Access Compliance Report

Public Rights-of-Way

(Curb Ramps)

Intersection ID: 11463	Main Street: ABERDEEN_ST	Cross Street: WHITEHALL_DR	Location:	E
ADA ID: C74836A63131	Ramp Type: BlendTrans1	Initial Pass/Fail: Fail	Overall Compliance: No	Severity Score: 12.5
Codes/Mitigation Info/Possible Solution		Field Measurements/Component Compliance

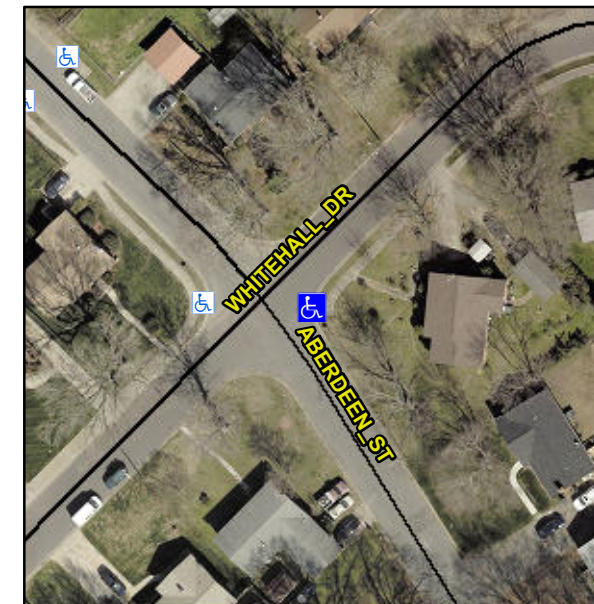
Not Found, R304.5.3

Compliance	Description	Data	Compliance	Description	Data
N/A	Ramp Length (in)	48.0	Yes	BlendTrans Slope (%)	3.3
Yes	Ramp Width (in)	48.0	No	BlendTrans XSlope (%)	5.4
N/A	Flare Type LT	N/A	N/A	Flare Type RT	N/A
N/A	Flare Slope LT (%)	N/A	N/A	Flare Slope RT (%)	N/A
N/A	Flare Traversable LT?	N/A	N/A	Flare Traversable RT?	N/A
N/A	Landing Length (in)	N/A	N/A	DWS Provided?	N/A
N/A	Landing Width (in)	N/A	N/A	DWS Contrast?	N/A
N/A	Landing Slope (%)	N/A	N/A	DWS Length (in)	N/A
N/A	Landing X Slope (%)	N/A	N/A	DWS Full Width?	N/A
N/A	Landing Curb? (Y/N)	N/A	N/A	DWS Offset (in)	N/A
N/A	Shared Landing?	N/A			
N/A	Gutter Ponding?	Yes	N/A	Gutter Slope (%)	N/A
N/A	Gutter Lip Ht (in)	N/A	N/A	Gutter X Slope (%)	N/A
N/A	Painted X Walk1?	No	N/A	Painted X Walk2?	No
	X Walk 1 Direction	To NW		X Walk 2 Direction	To SW
	X Walk 1 Width (in)	N/A		X Walk 2 Width (in)	N/A
	X Walk 1 Slope (%)	4.5		X Walk 2 Slope (%)	N/A
	X Walk 1 X Slope (%)	7.2		X Walk 2 X Slope (%)	N/A

N/A	Ramp inside XWalk1?	N/A	N/A	Ramp inside XWalk2?	N/A
	Road Slope (%)	7.2		Clear Space?	N/A
	Road X Slope (%)	4.5	N/A	Clear Space to XWalk (in)	N/A
N/A	Any Obstructions?	N/A	N/A	Storm Grate/Utility Hazard?	N/A
	Obstruction Type			Storm Grate/Utility Type	
		N/A			N/A
			Yes	Surface Condition? (G/P)	Good
			No	Curb Slope (%)	17.2

Remove & Replace Curb Ramp With Two New Directional Ramps or Equivalent.
